Serial: RNP-RA/12-0017

MAR 16 2012

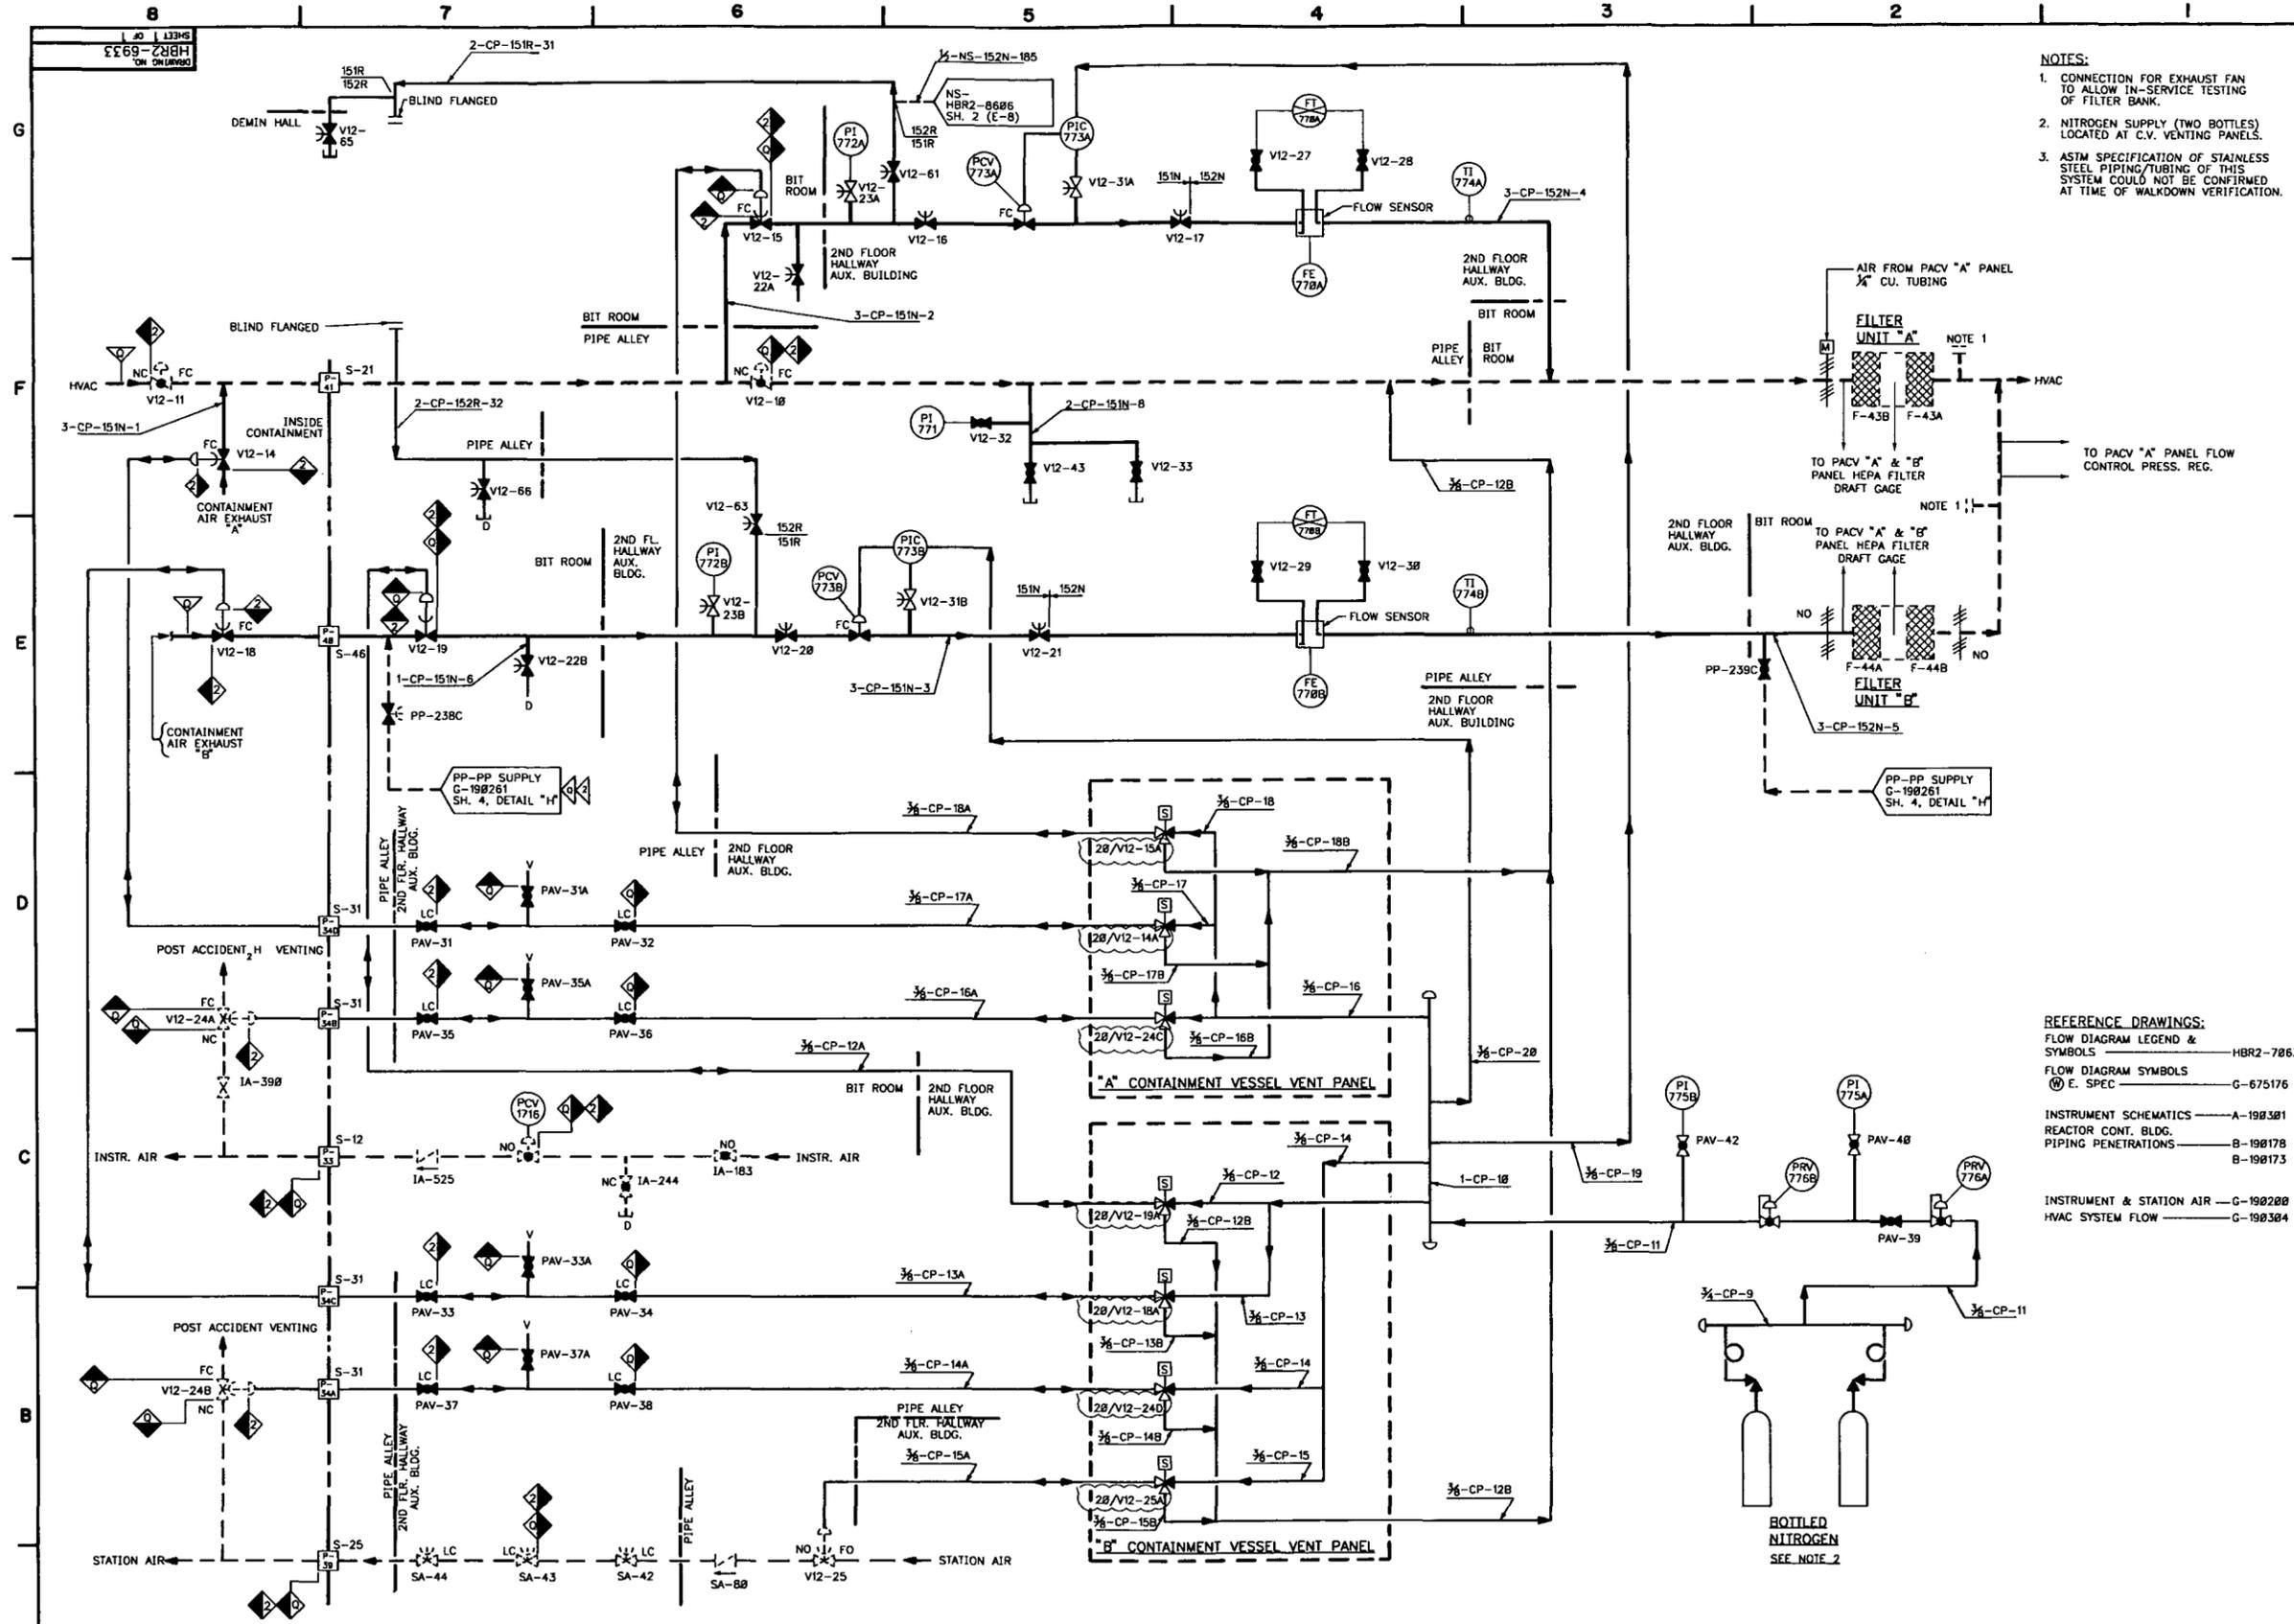
NO.	REVISION	DATE	BY	CHKD.	APP'D.
1	REVISED PER WALKDOWN PER WALKDOWN TO SUPERSEDE DWG. HBR2-6933 REV. 2. CHK: R. CHEWNING APPR: M. LLOYD DATE: 11-14-88	11-14-88	M. LLOYD	R. CHEWNING	
2	REVISED PER WALKDOWN PER WALKDOWN TO SUPERSEDE DWG. HBR2-6933 REV. 2. CHK: R. CHEWNING APPR: M. LLOYD DATE: 11-14-88	11-14-88	M. LLOYD	R. CHEWNING	
3	REVISED PER WALKDOWN PER WALKDOWN TO SUPERSEDE DWG. HBR2-6933 REV. 2. CHK: R. CHEWNING APPR: M. LLOYD DATE: 11-14-88	11-14-88	M. LLOYD	R. CHEWNING	
4	REVISED PER WALKDOWN PER WALKDOWN TO SUPERSEDE DWG. HBR2-6933 REV. 2. CHK: R. CHEWNING APPR: M. LLOYD DATE: 11-14-88	11-14-88	M. LLOYD	R. CHEWNING	
5	REVISED PER WALKDOWN PER WALKDOWN TO SUPERSEDE DWG. HBR2-6933 REV. 2. CHK: R. CHEWNING APPR: M. LLOYD DATE: 11-14-88	11-14-88	M. LLOYD	R. CHEWNING	
6	REVISED PER WALKDOWN PER WALKDOWN TO SUPERSEDE DWG. HBR2-6933 REV. 2. CHK: R. CHEWNING APPR: M. LLOYD DATE: 11-14-88	11-14-88	M. LLOYD	R. CHEWNING
